MFN 09-380

Subject: Response to Portion of NRC Request for Additional Information Letter No. 312 Related to ESBWR Design Certification Application - Auxiliary Systems - RAI Number 9.4-29 S03

RAI Number 9.4-29 S03

Enclosure 2

Figure 9.4-29-S3-1, GOTHIC™ Model MCR Temperature elevation / Gradient Map at Design Heatup Condition

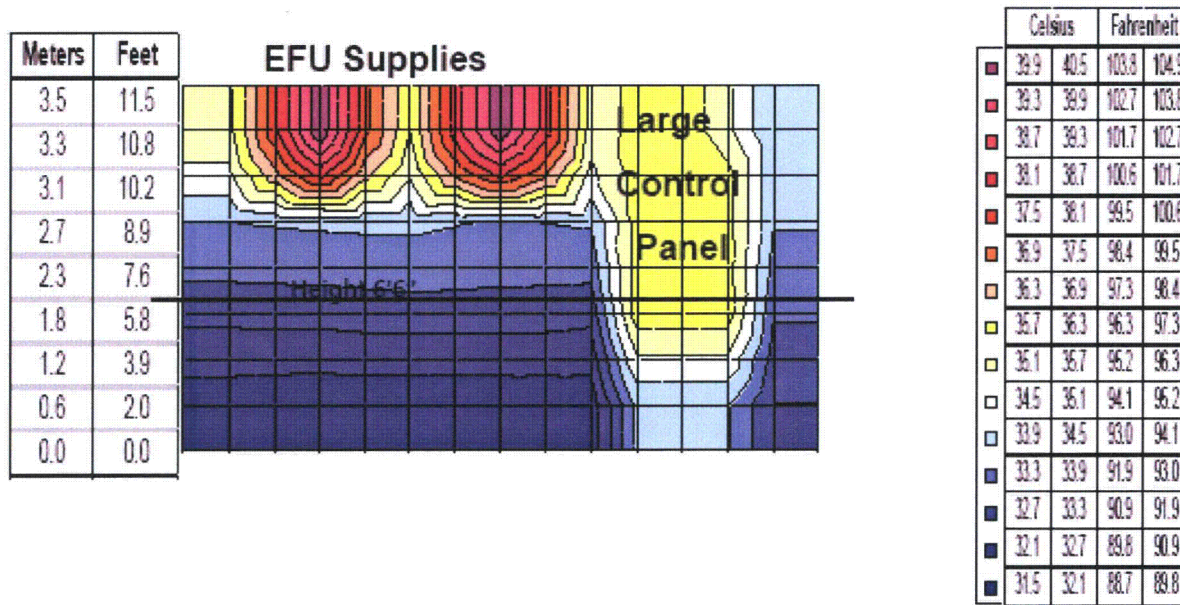
As previously discussed, a snapshot temperature profile is shown on Figure 9.4-29-S03-1, GOTHIC™ Model MCR Temperature elevation / Gradient Map at Design Heatup Condition. This figure represents the area above the raised floor up to the false (hung) ceiling.

Figure 9.4-29-S3-2, Control Room Habitability Area Airflows Emergency Operation - Based Upon Gothic™ Analysis Results

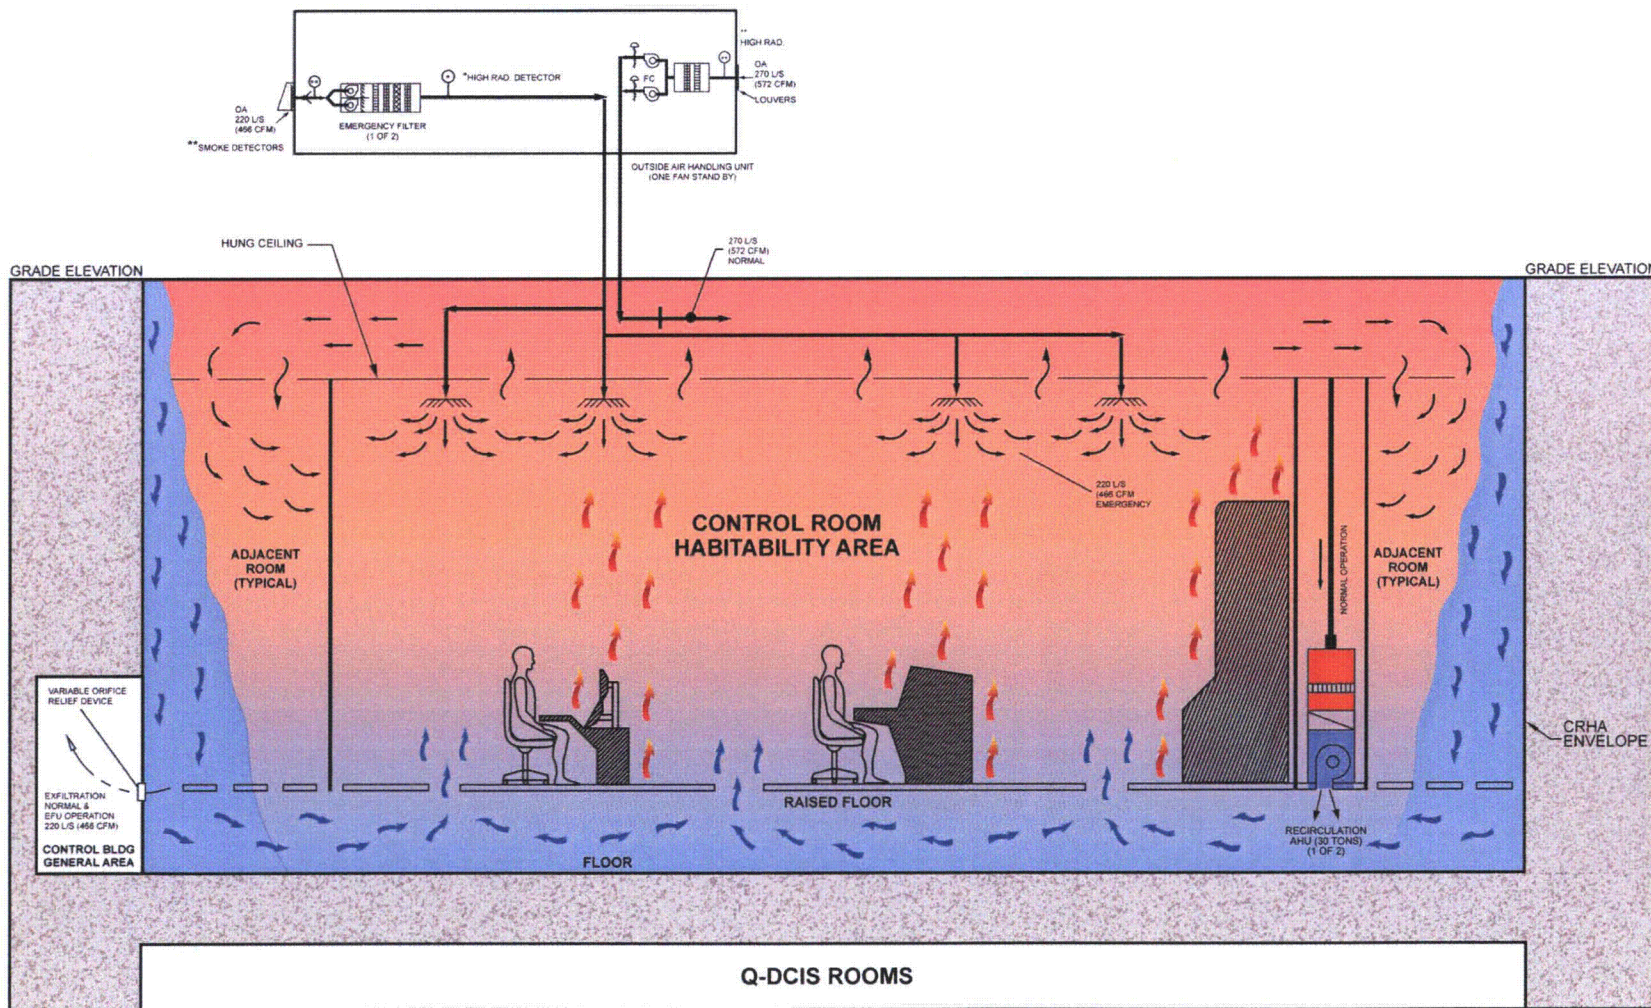
The airflow developed in the ESBWR control room during worst case (outside air temp of 117°F) accident conditions when the CRHA is isolated and the EFU is in operation with passive cooling is as follows and is illustrated on Figure 9.4-29-S3-2, Control Room Habitability Area Airflows Emergency Operation - Based Upon Gothic™ Analysis Results:

The EFU is operating providing 466 cfm clean outside airflow into the CRHA. This is delivered to the occupied MCR area, primarily since this area has the personnel on duty and houses the active electronic equipment. This supply air exits the ductwork at supply air diffusers (4), which perform mixing mechanism 1) above. Depending upon the delivered air temperature, the combined mixed volume either rises or drops. At the worst case outside air condition of 117°F, modeling shows this air mixture rises above the ceiling with a larger quantity of MCR heated air; the balance driven primarily by the equipment and personnel convective plumes (mechanism 3) above). The

combined, rising air above the ceiling tiles draws the same quantity of air into the MCR space from the area below the raised floor volume (mechanism 2). This cooler, slow moving air slowly spreads over the raised floor and displaces the warmer, stale air toward the ceiling, where it leaves the room. The MCR with the high ceiling becomes thermally stratified, i.e., warmer stale air is concentrated above the occupied zone and cool, fresher air is concentrated in the occupied zone. When the cool air encounters a heat source, such as a person or heat generating equipment, the air heats up and buoyantly rises out of the occupied zone.

The hot air that collects above the suspended ceiling, with CO₂ and body generated odors, spills over into the adjacent rooms due to the air density difference due to differential temperature where heat is released to the cooler walls and concrete. Cooler lower temperature air in these adjacent rooms drops to the raised floor level where air continues to drop thru to the common space below the floor. Discharge flow of 466 cfm of this air, exits the main control room at a remotely opposite location from EFU supply to prevent any short cycle of the supply air and ensure a constant turnover of the CRHA air. This air then is drawn into the MCR and a circuit is complete.

A positive pressure is maintained in the CRHA. There is no buildup of any CO₂ in any of these areas since the areas are scavenged continuously by the EFU supply with exhaust airflow of 466 cfm. The exhaust is remote to the supply at one of the adjacent rooms lower common area.

Figure 3H-2. Control Room Habitability Area Transient Analysis Heat up Profile—0% Exceedance Maximum Temperature Case

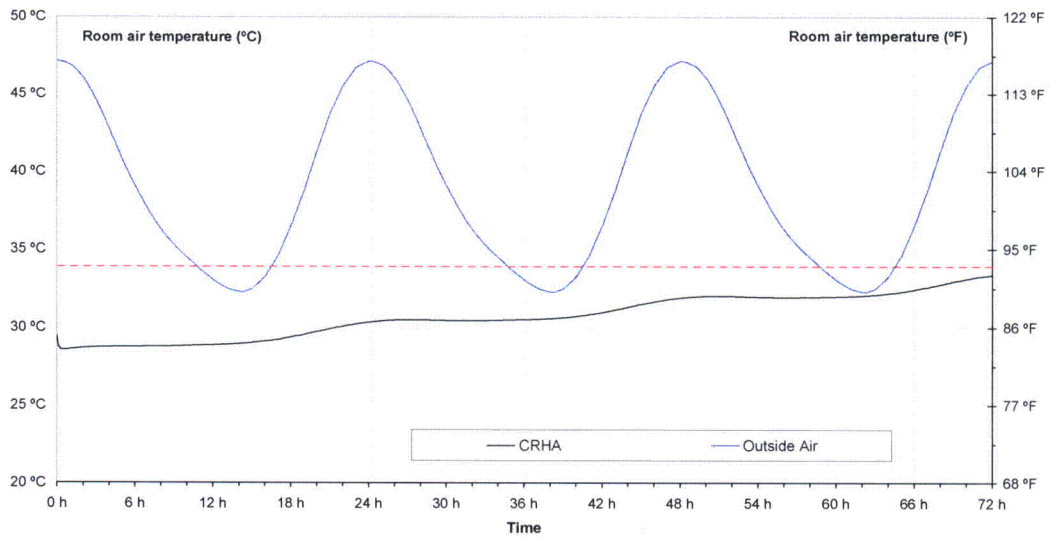
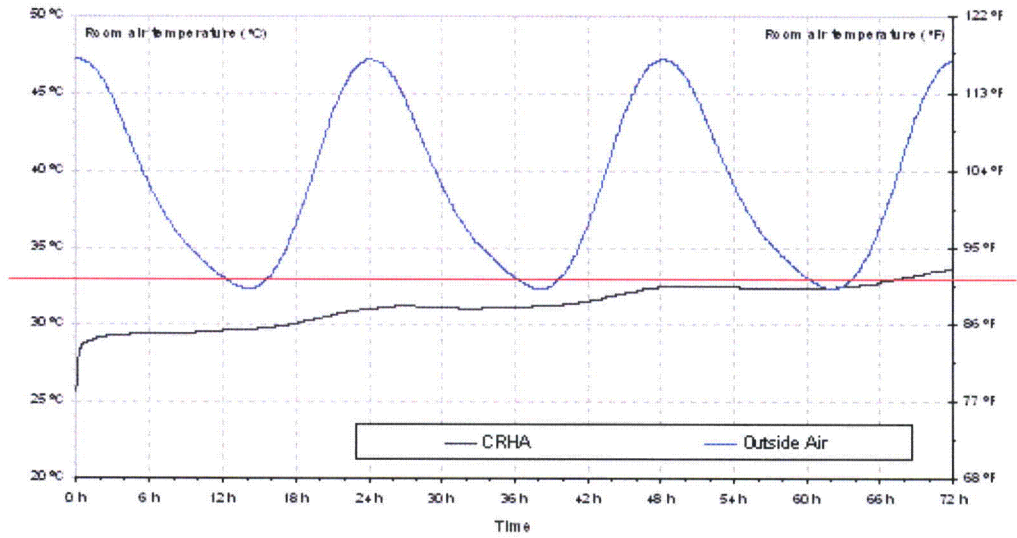
The NRC has accepted the guidance for temperature and humidity for other plant control room habitability area ventilation systems contained in MIL-HDBK-759C, 31 July 1995, "Human Engineering Design Guidelines". MIL-HDBK-759C states that an effective temperature of 29.5°C (85.1°F) should be considered the maximum limit for reliable human performance. The effective-temperature ranges are flexible because they vary according to the amount of work activity. In general, the ranges should be extended upwards for tasks requiring minimal physical effort. The Wet Bulb Globe Temperature (WBGT) index is more applicable than the effective-temperature index in the range beyond the comfort and discomfort zones of heat stress. As described in NIOSH 86-113, "Criteria for a Recommended Standard: Occupational Exposure to Hot Environments" (Revised Criteria 1986), the psychrometric wet bulb temperature may be an appropriate index for assessing heat stress and predicting heat strain under conditions where radiant temperatures and air velocity are not large factors and where increased humidity exist. NIOSH 86-113 provides a wet bulb temperature limit of about 30°C (86°F) for unimpaired performance on sedentary tasks (moderate levels of physical work) for normally clothed individuals at low airflows. Considering a maximum CRHA humidity of 60% (reference RAI 6.4-21 Figure 6.4-21-1), and a maximum dry bulb temperature of 93°F (design limit), the corresponding wet bulb temperature determined is less than 81°F. This is below the 86°F wet bulb temperature threshold. Therefore, no heat stress concerns exist. DCD Chapter 6 has been revised to include a statement describing the 86°F wet bulb temperature limit. DCD Figures 3H2 and 3H3 have been revised to reflect Temperature and Relative

DCD Tier 2 Chapter 3, figures 3H2 and 3H3:

These figures were revised per an Engineering Change and are attached to reflect the latest system design analysis.
